ADDENDUM No. 1
Request for Competitive Sealed Proposals (CSP)
19CSP085- Renovations at Casey Elementary

CASEY ELEMENTARY SCHOOL
RENOVATIONS AT CASEY ELEMENTARY SCHOOL

ADDENDUM NO. 01: December 21, 2018

Sheet:
MP3.5

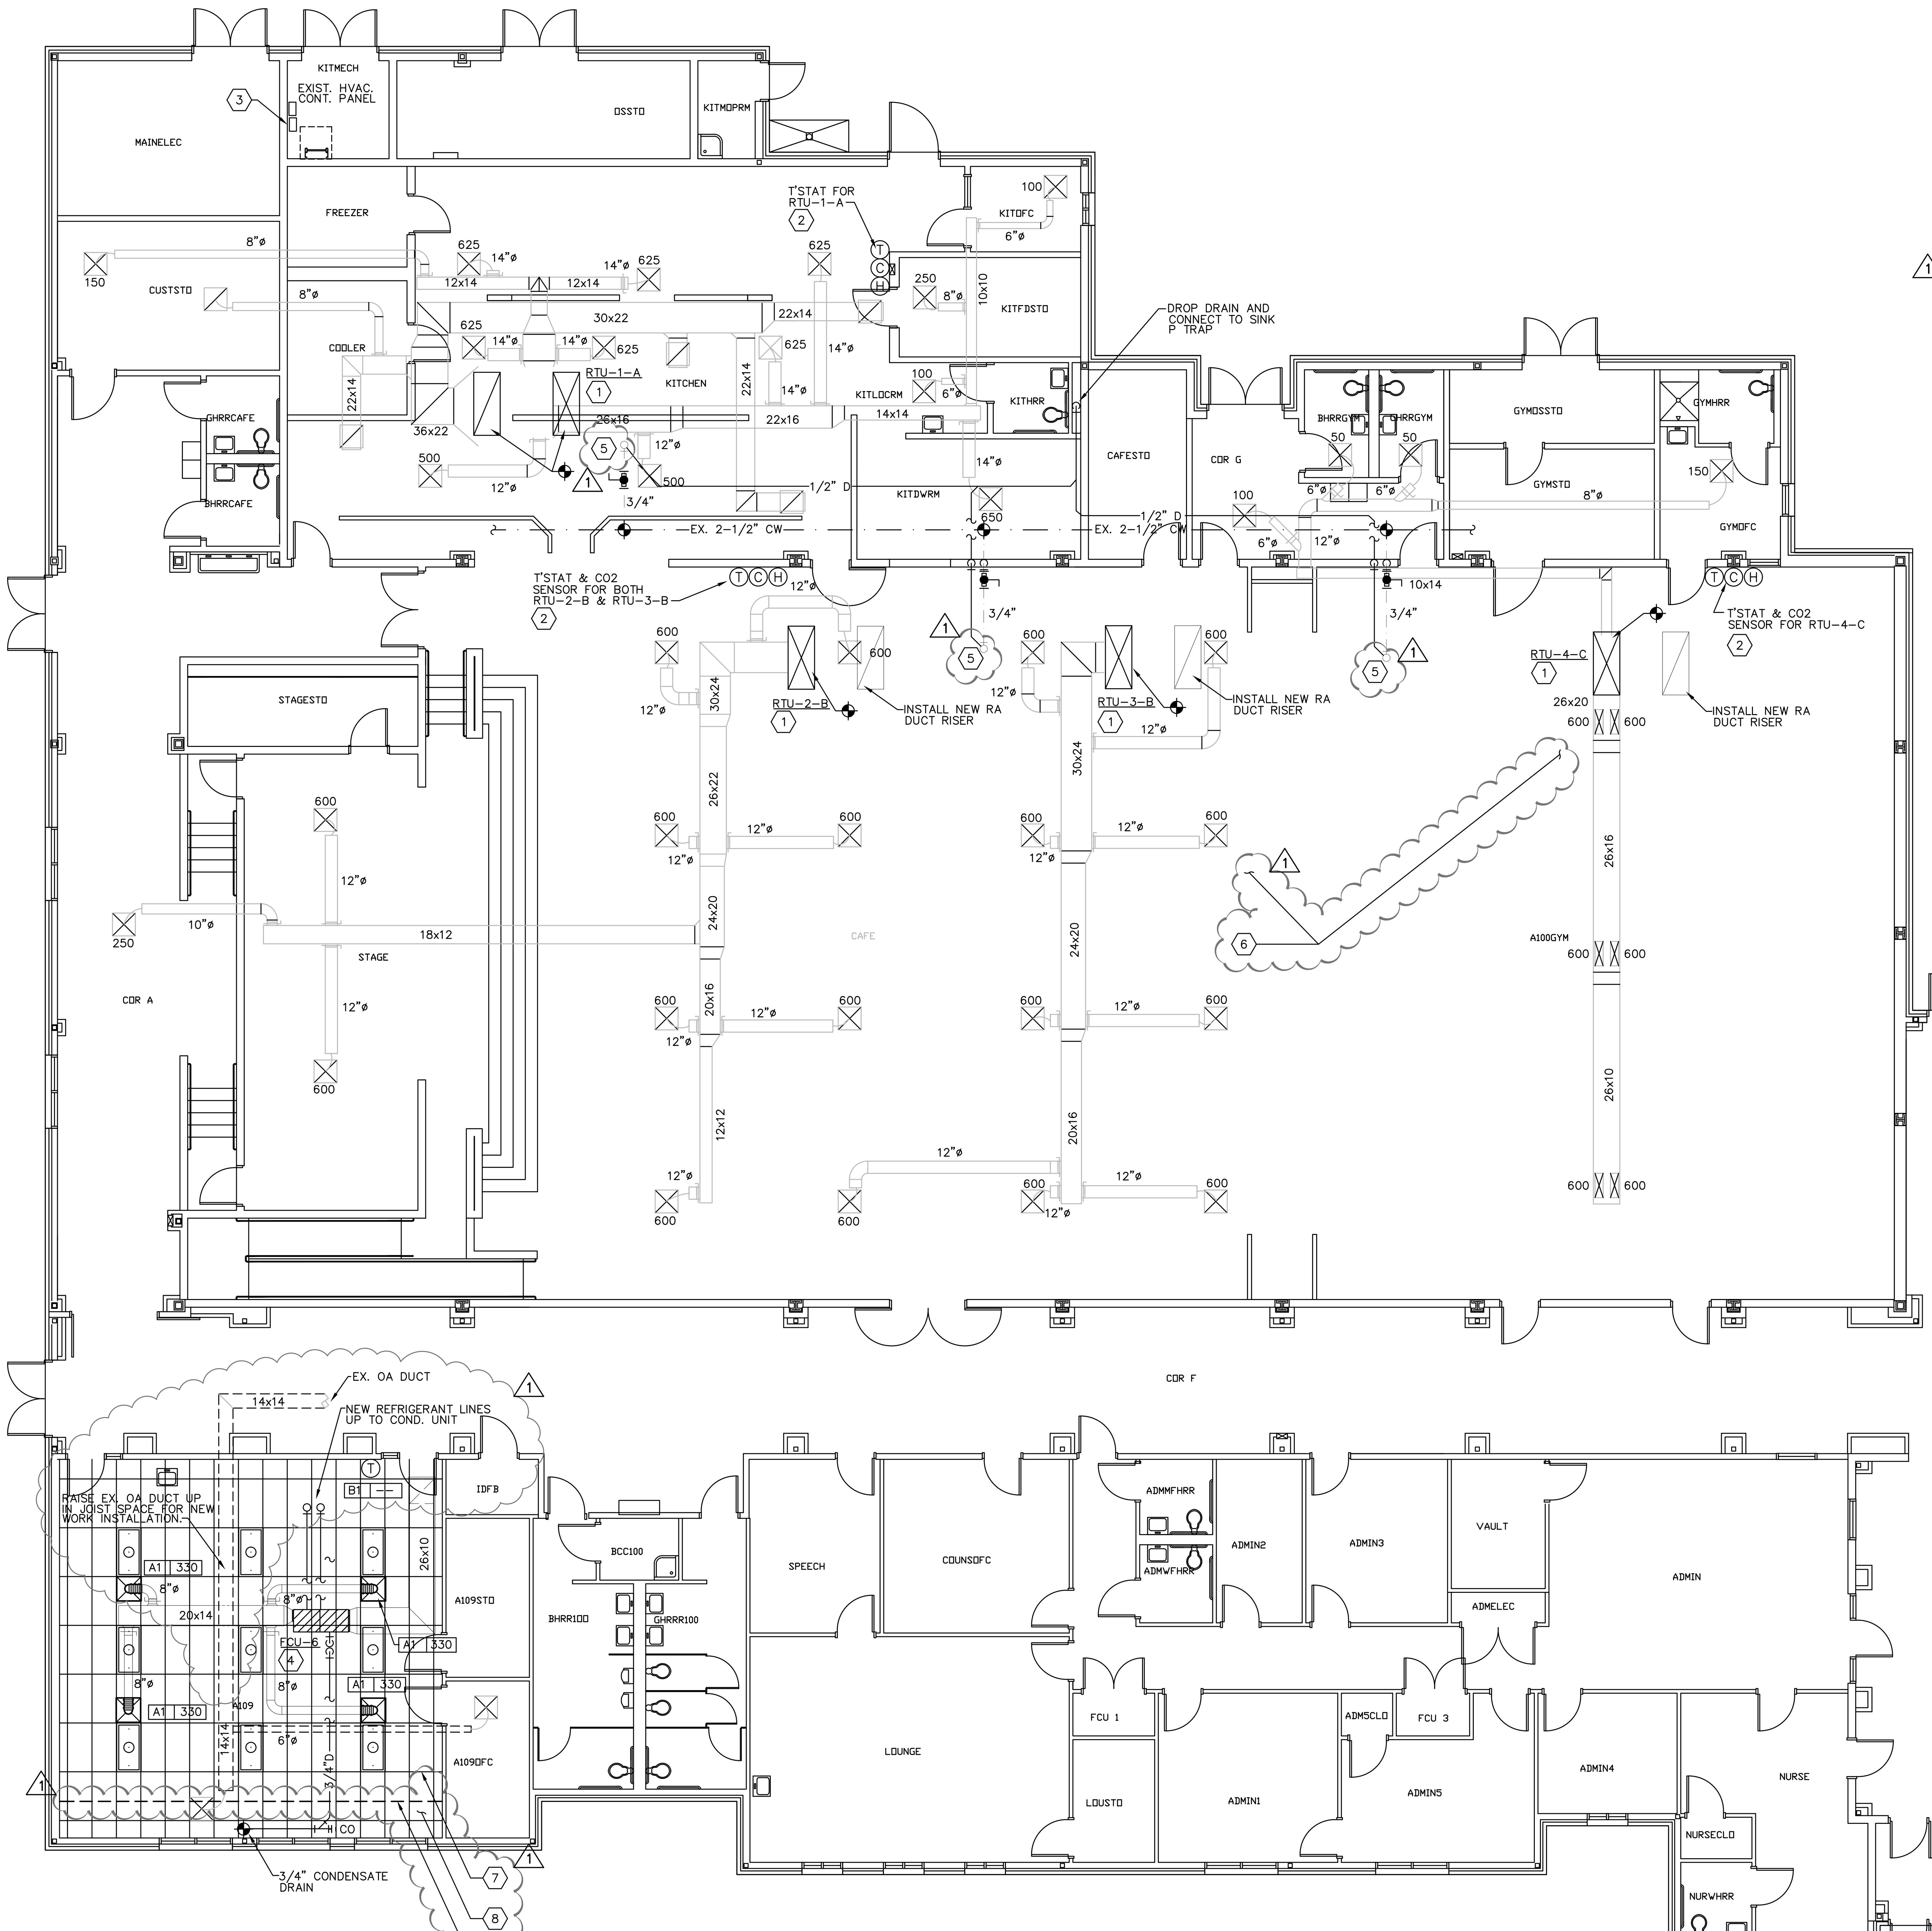
Revised requirement in Construction Note 3.c. for work associated with condensate piping.
5. MP3.5
   - Added Keyed Note 2 to indicate that plywood is to be used to protect the existing roof during construction.

Sheet: MP6.1

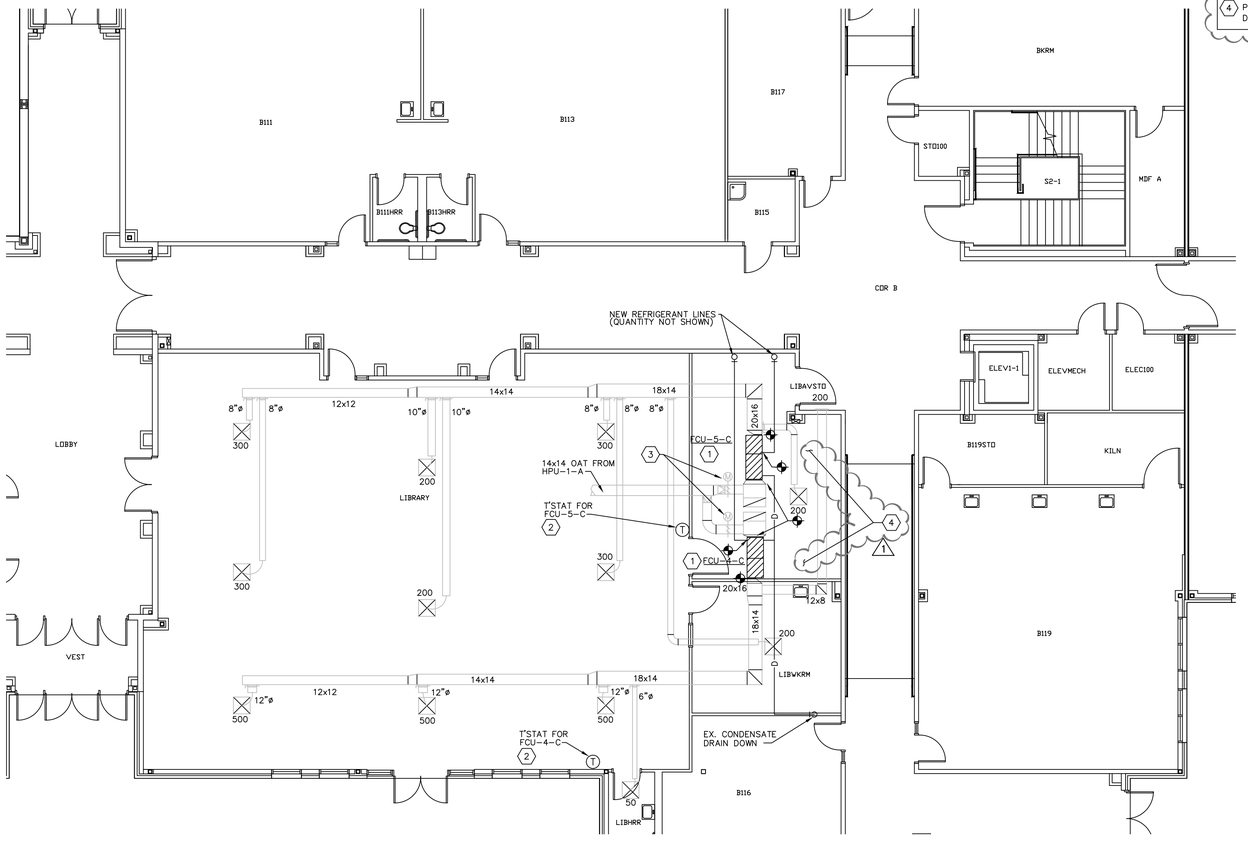
6. MP6.1
   - Added Keyed Note and updated Construction note to indicate new roof hydrants.
   - Added Keyed Notes 6,7, 8, and 9 to indicated work associated with ceiling and floor to support the MEP work

5. INSTALL NEW ROOF HYDRANT. REFERENCE DETAIL M7.1/1 FOR ADDITIONAL INFORMATION.
6. REINSTALL EXISTING CEILING GRID AND CEILING TILE THAT WAS REMOVED FOR ACCESS TO EQUIPMENT REPLACEMENT.

Sheet: **MP6.2**

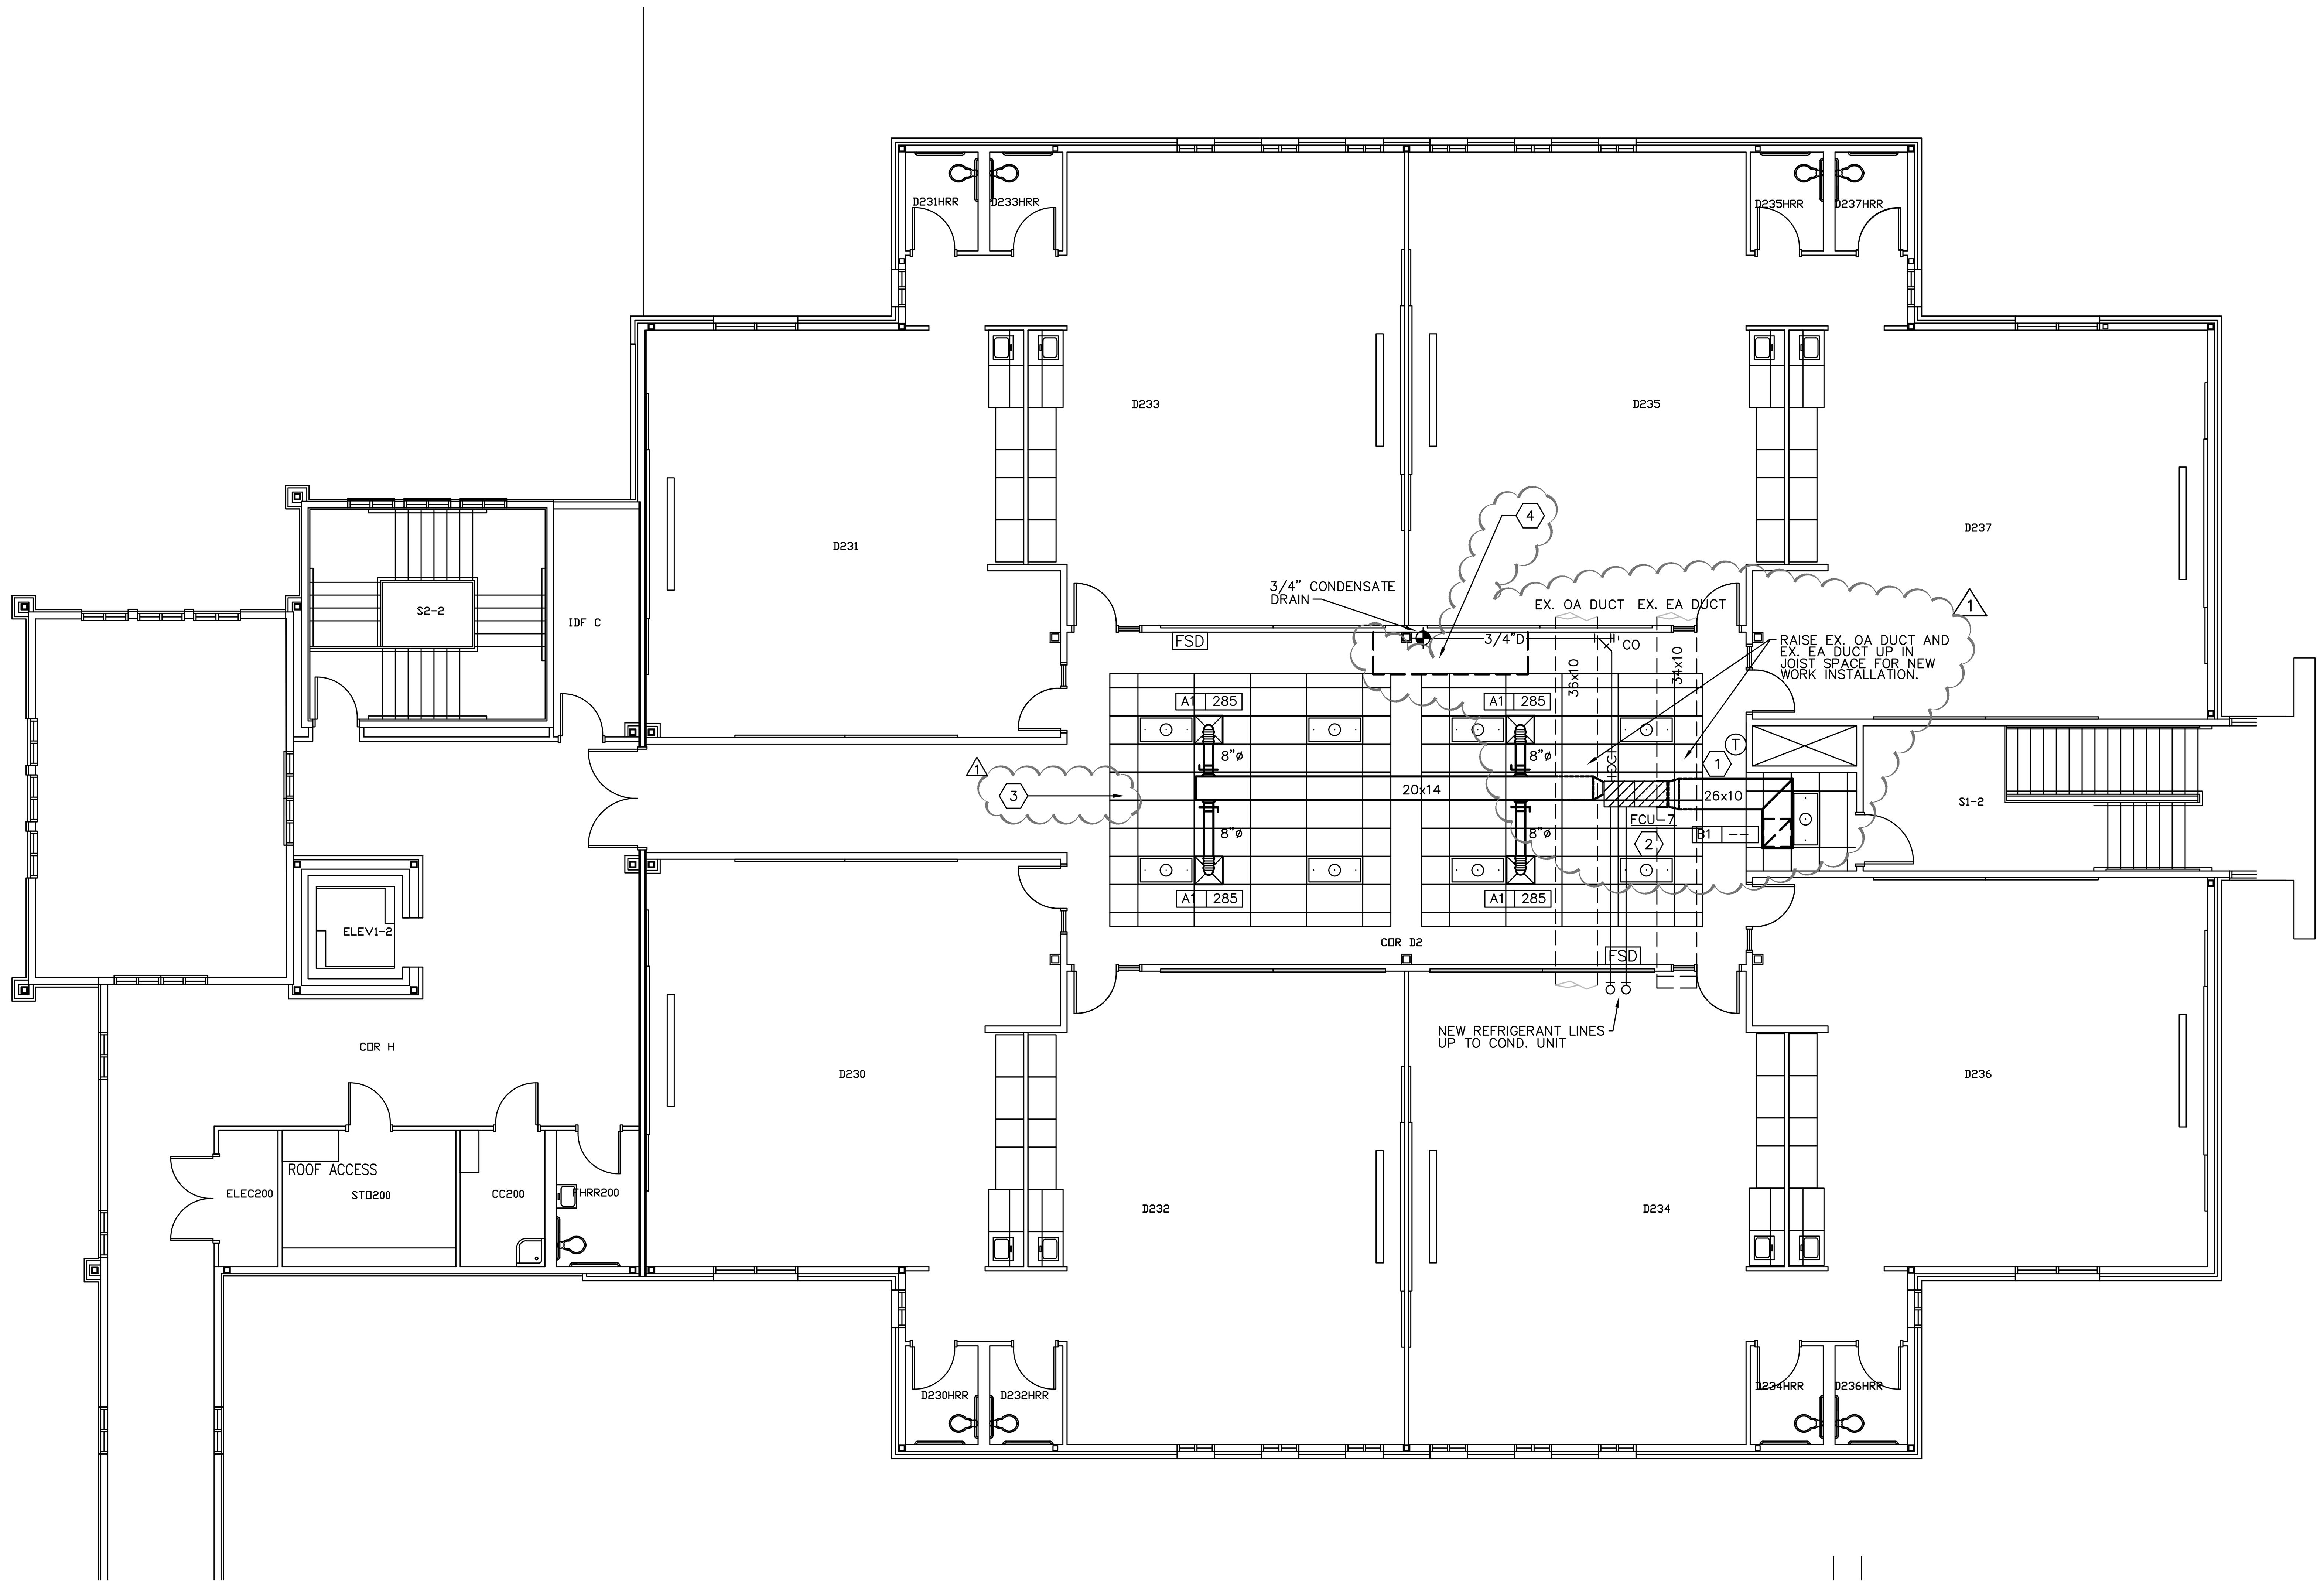
7. MP6.2
   - Added Key Note 4 to indicate work associated with ceiling.

Sheet:
MP6.3

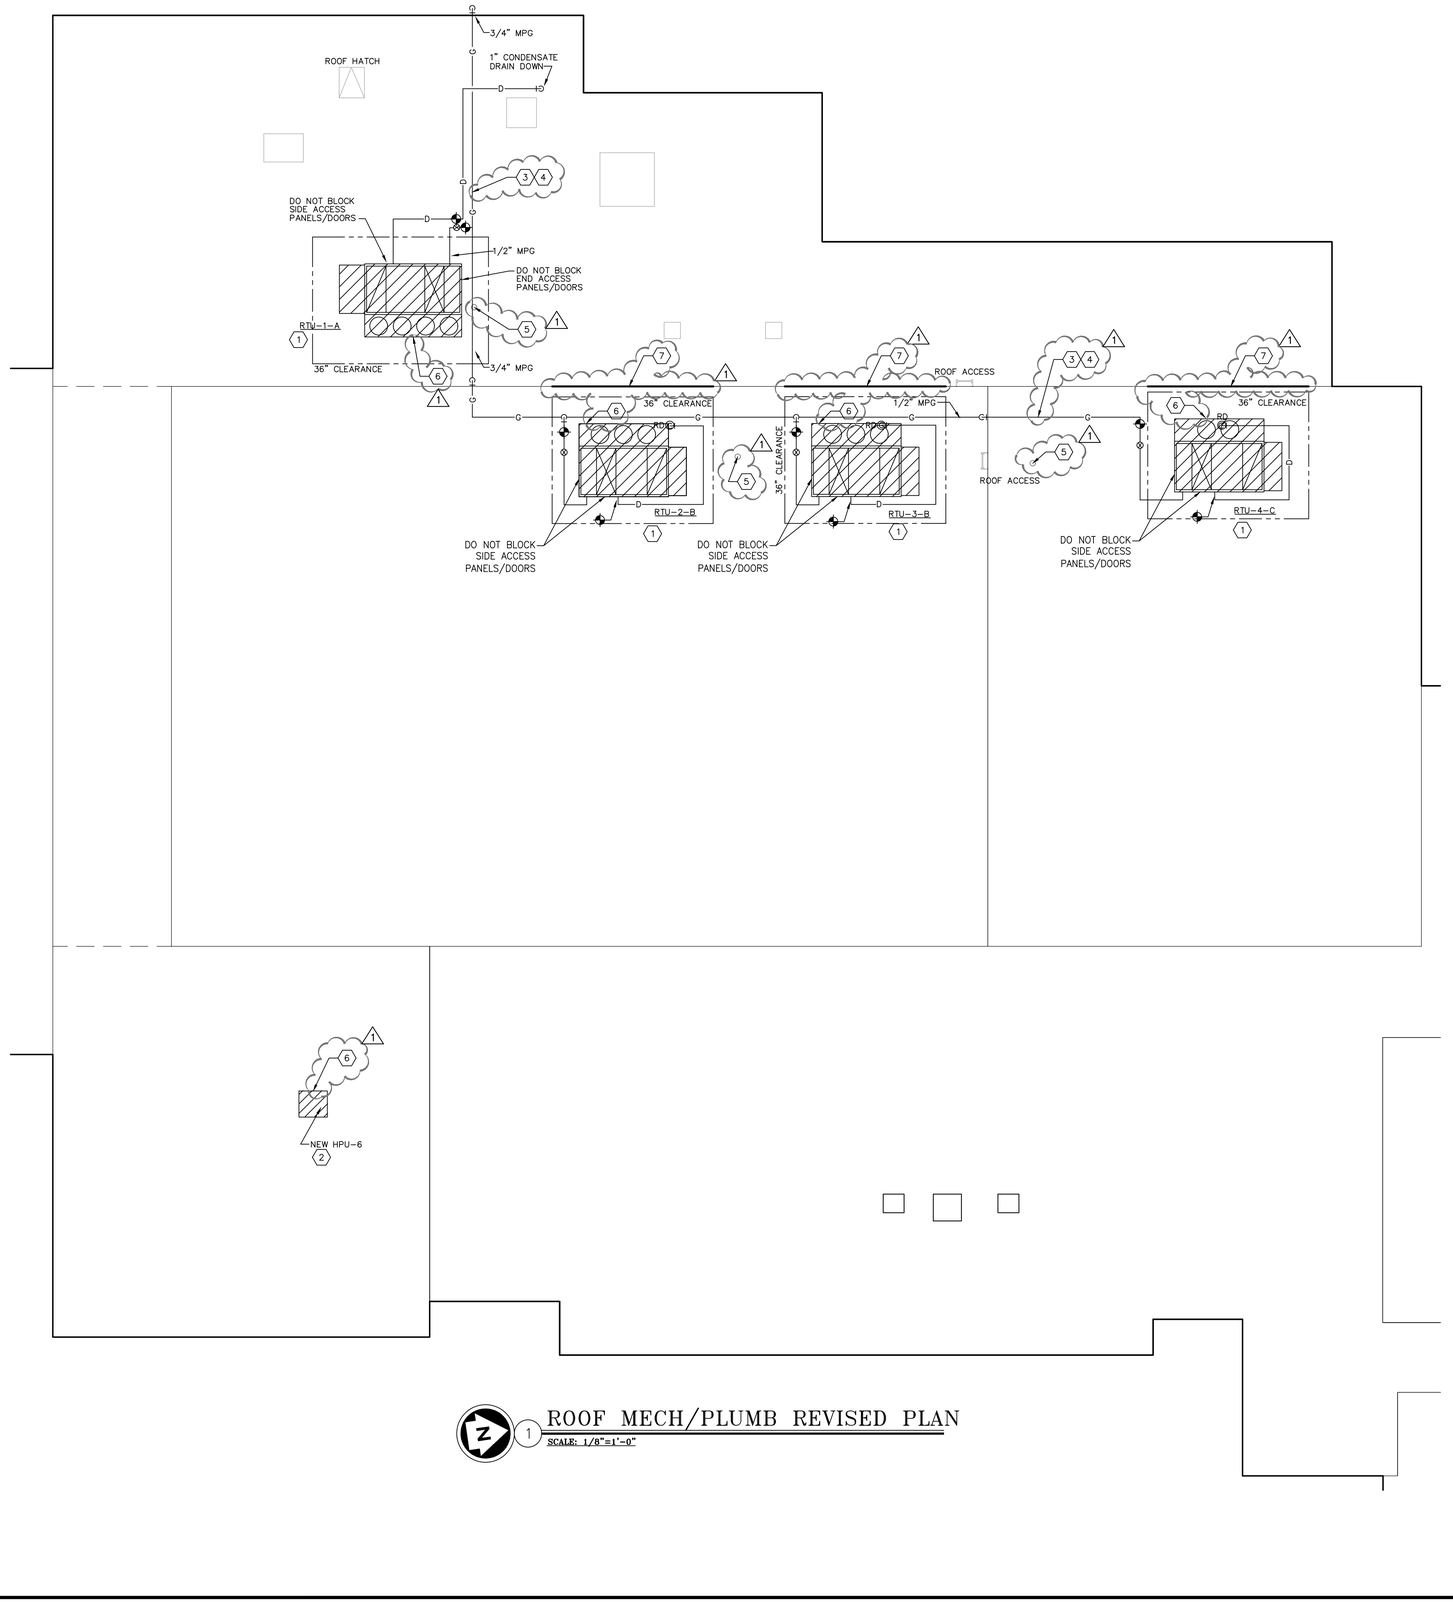
8. MP6.3
   Added Keyed Notes 3 and 4 to indicated work associated with ceiling and floor to support the MEP work.
